APPLICATION FOR PERMISSION
UNDER SECTION 16 OF
THE TOWN PLANNING ORDINANCE
(CAP. 131)

For Official Use Only 請勿填寫此欄	Application No. 申請編號	A/TL-KN/1020
	Date Received 收到日期	24 MAY 2024

A/YL-KTN/1020
回應規劃署的提問

A/YL-KTN/1020

圖
同
布

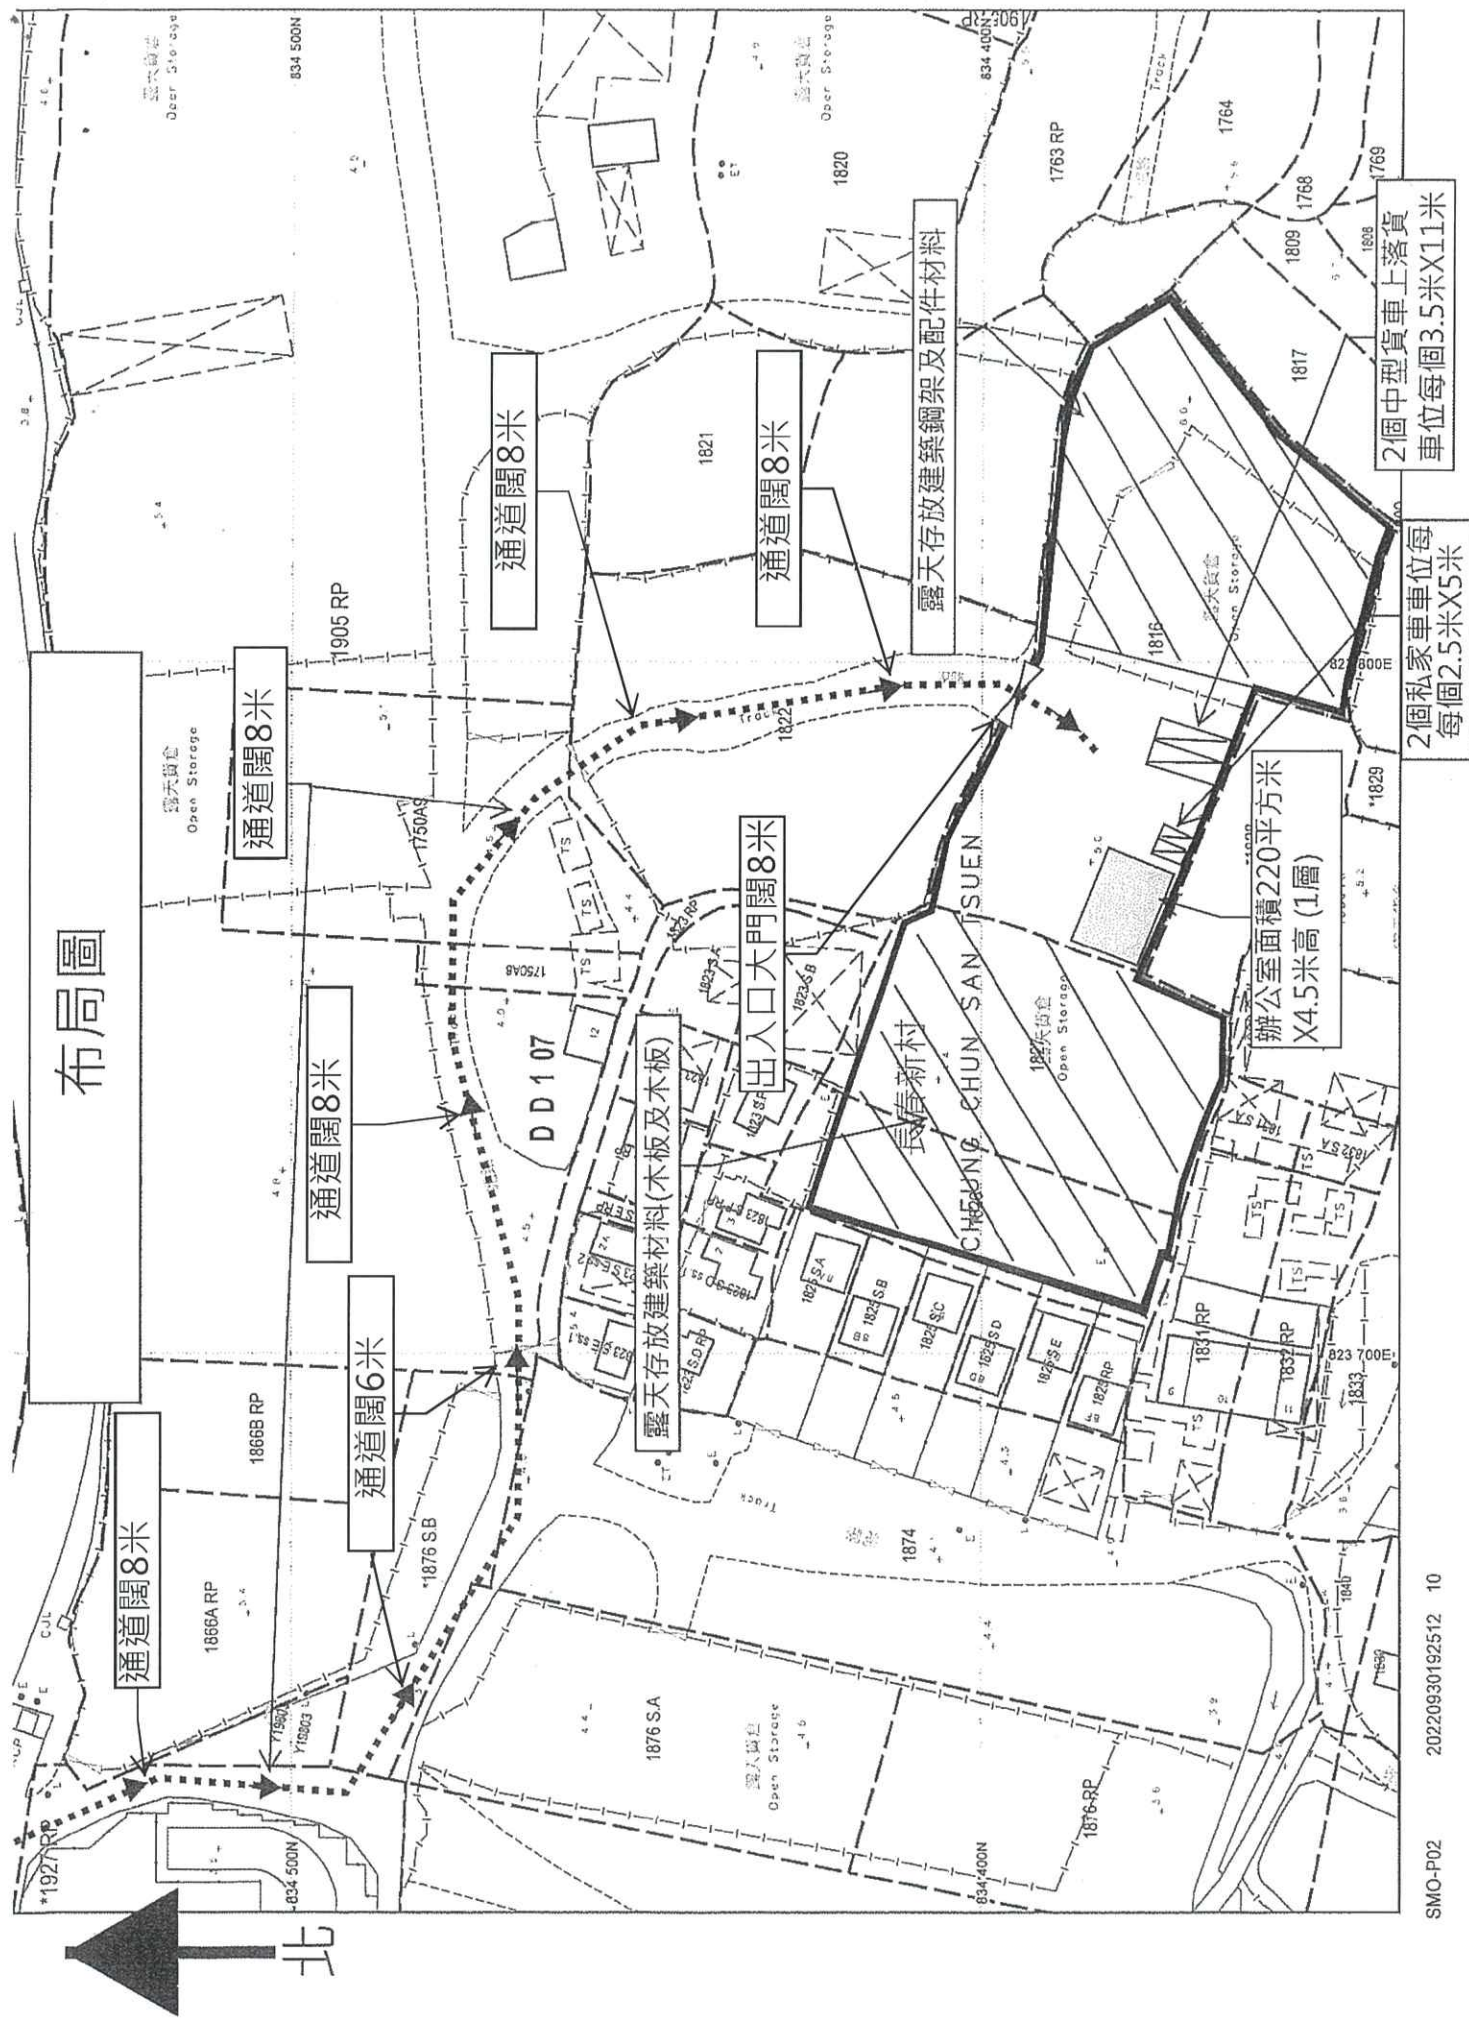
(b) The applicant should demonstrate the smooth manoeuvring of vehicles to / from Castle Peak Road - Tam Mi, along the local access and within the site;

(c) The applicant should indicate the clear width of the vehicular ingress / egress on the layout plan;

b 我等已在布局圖內列明水尾路至場地內行車通道的闊 6-8 米而場地至水尾路口起至青山公路潭尾段的行車通道須然是單線雙程行車，全程約 412 米其中設有 5 個避車處平均 80 米便有一個，因此絕對不會影響車輛通行而我等場地每日出行次數不會超過 12 架次，因此對交通流量影響十分輕微。

c 已在布局圖內加上出入口的闊度說明。

現場相片位置說明

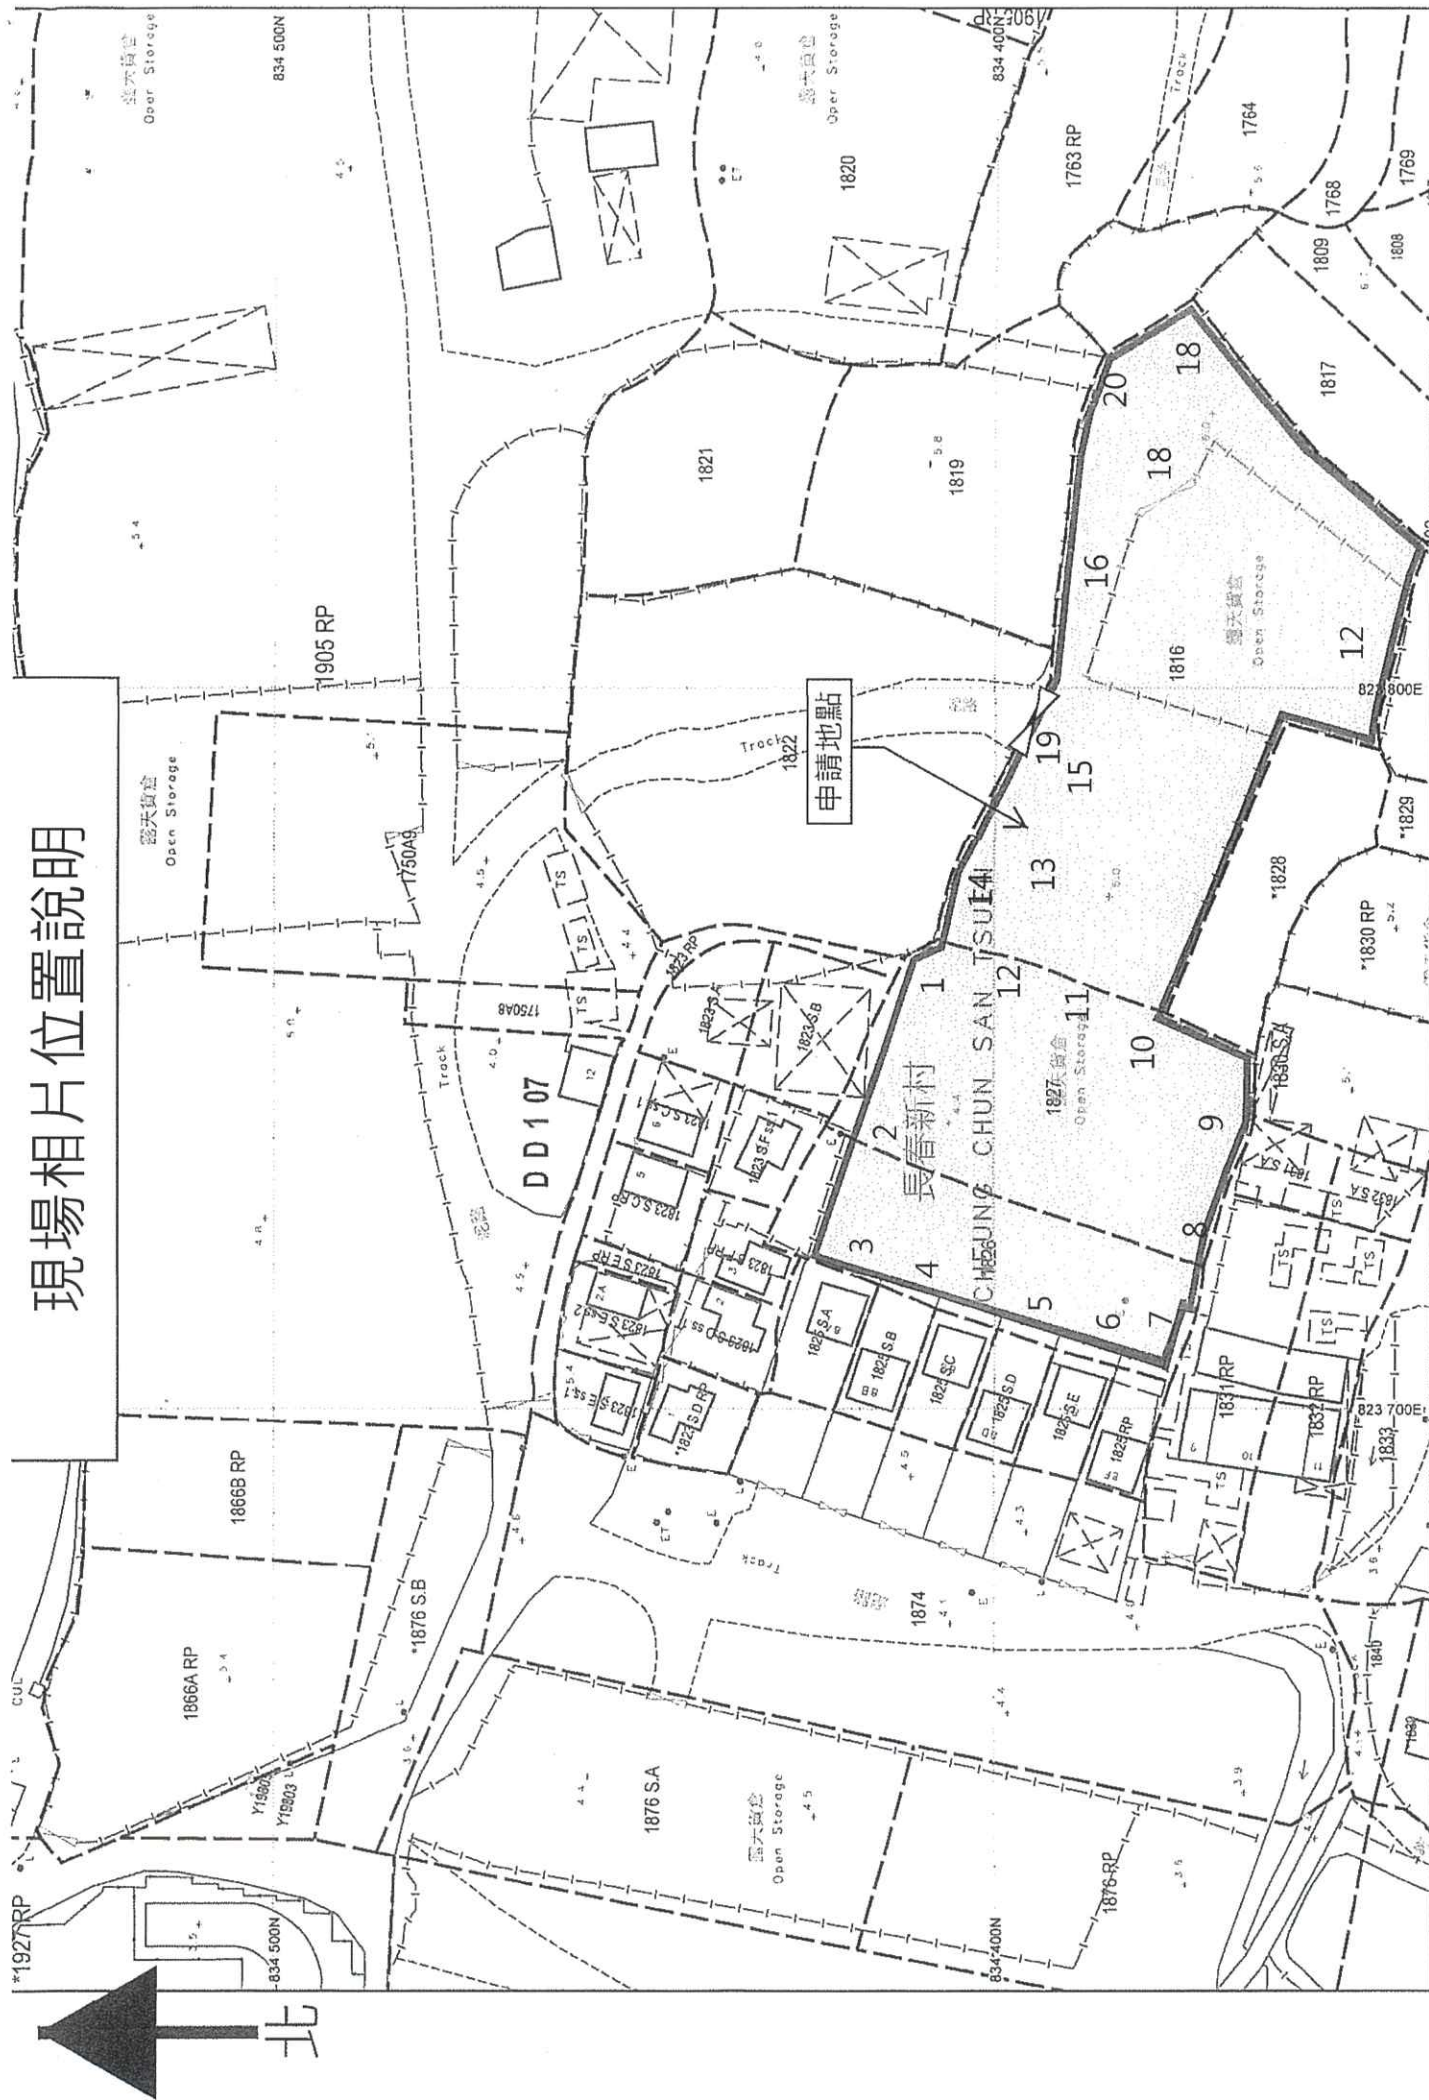
6. Please justify the existing 450UC and provide more photos along the channel to show its condition.
- 將會提供現場相片給貴署審視。(申請場地現場相片集)

雨水排放建議圖

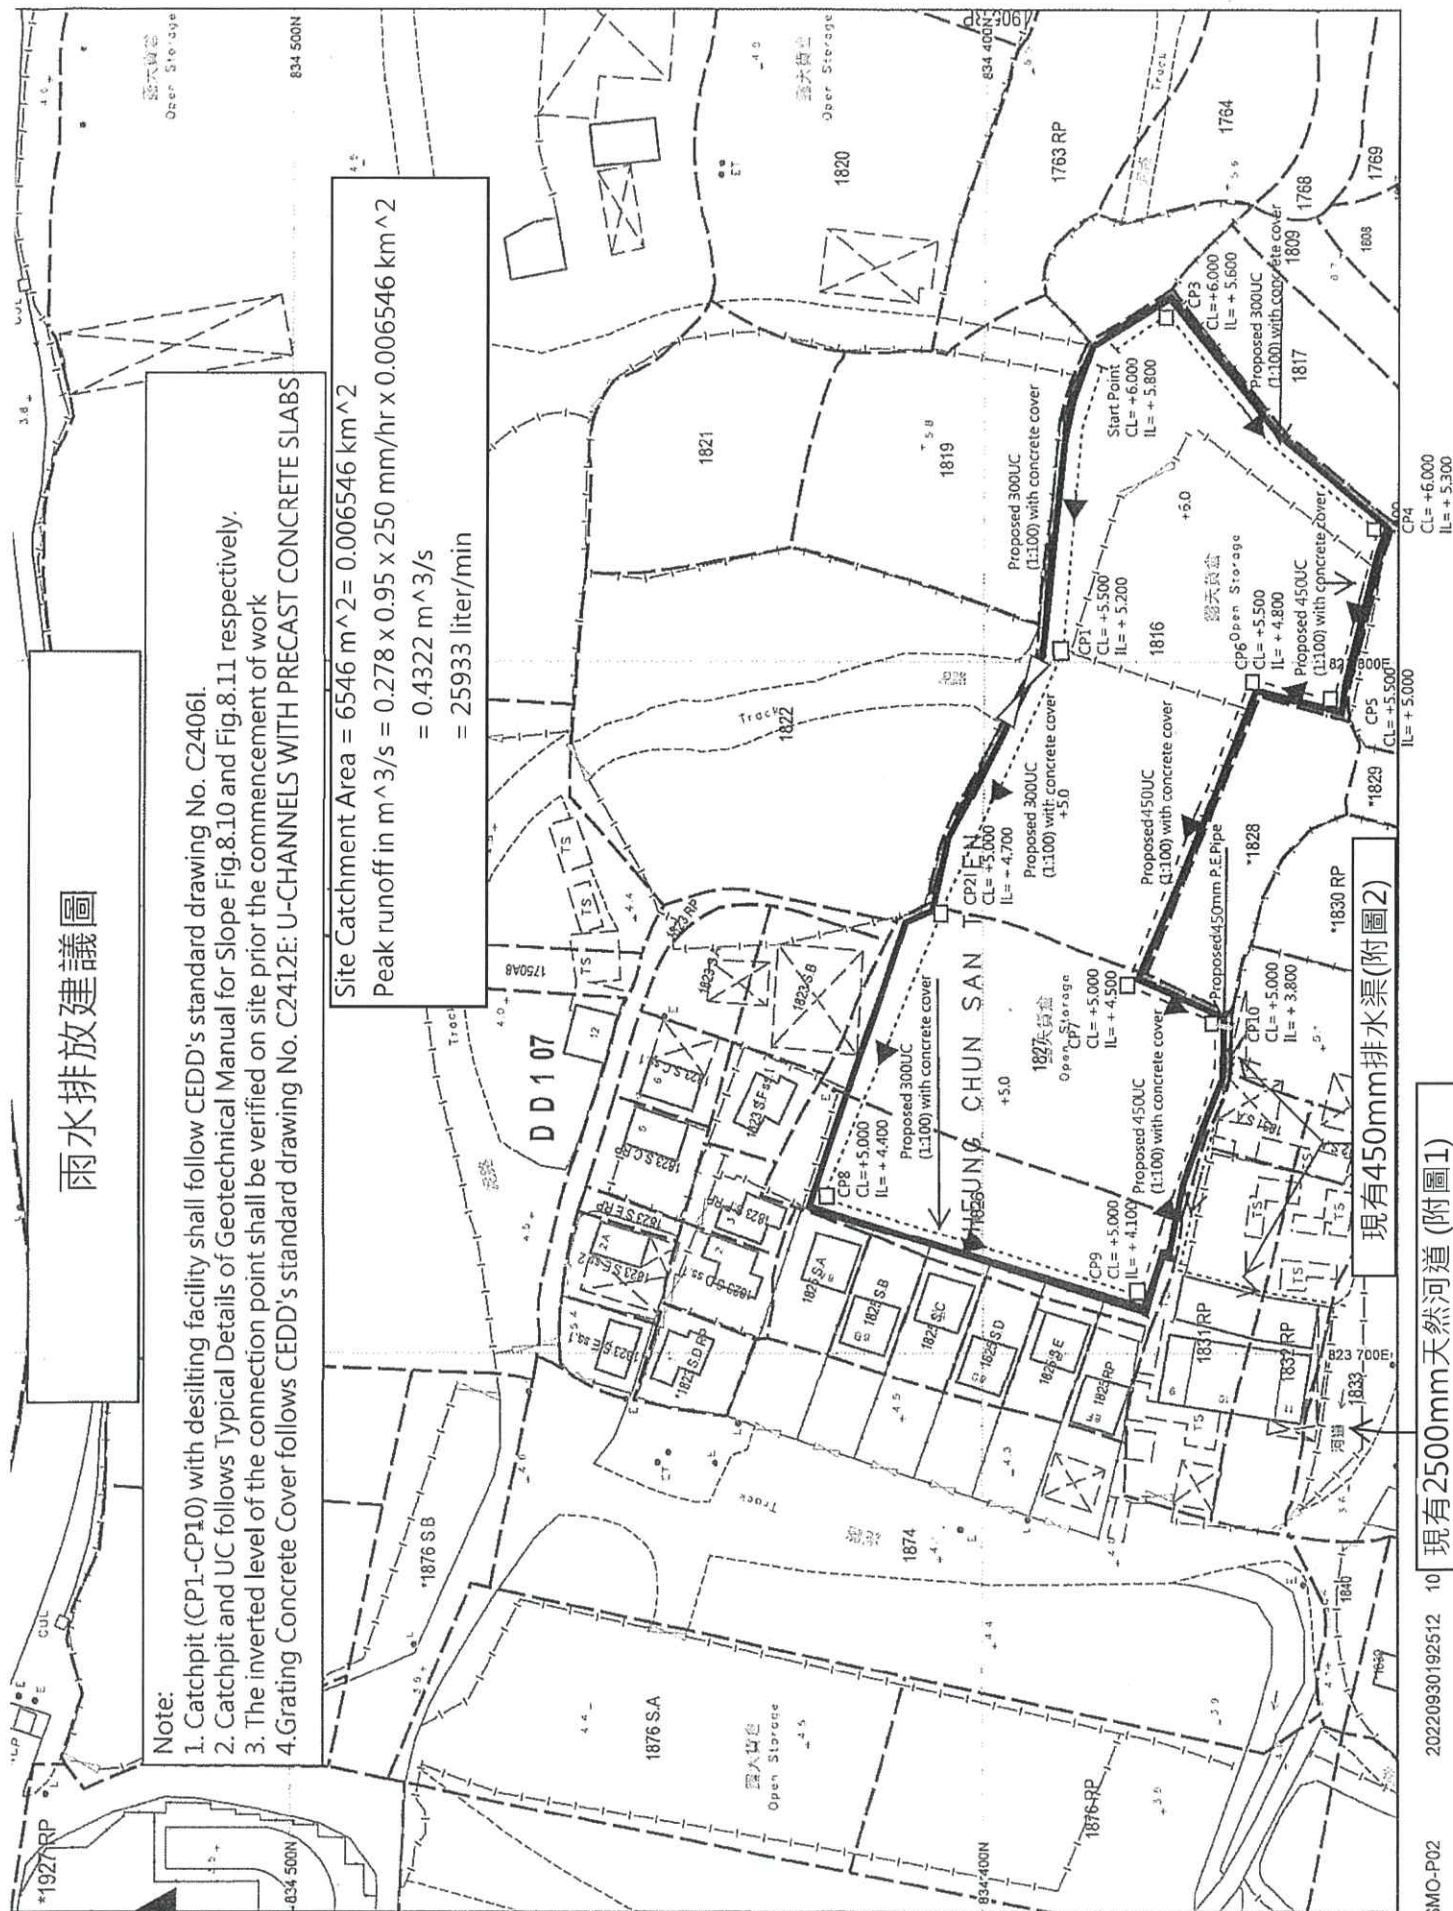
1. Please provide the catchment area plan for comment.

2. Please provide relevant design chart to justify the proposed u-channel sizes. The u-channel sizes appears to be undersized. Please review.

1. Previous comment (d) has not been addressed. Please provide flow direction within the application site.

2. Please advise why there are two sizes of u-channels (i.e. 300UC and 450UC). Please clearly demonstrate with hydraulic calculations.

3. Previous comment (c) has not been addressed. Please submit calculation demonstrating the downstream drainage system receiving the discharge from the development has adequate spare capacity to accommodate the runoff.

11. Connection details (including levels and sections) from CP10 to existing 450UC should be provided.

有關承接雨水範圍皆因我等地段大部份被其他圍板圍封，而有關圍板並非我等建造，實為其他地段業權人自行圍封，因此我等將會承接的雨水面積約為 7680 平方米。

我等已在新一份建議圖內加入有關雨水的流向。

隨函附上新一份計算表，而有關渠道設計，及從新計算和設計新一份建議圖給貴會署審議。

已在新一份建議書內連同計算表一並附上

我等會提供從 CP10 到現有 450UC 的連接細節 (包括標高和截面)。連同此函一並附上。
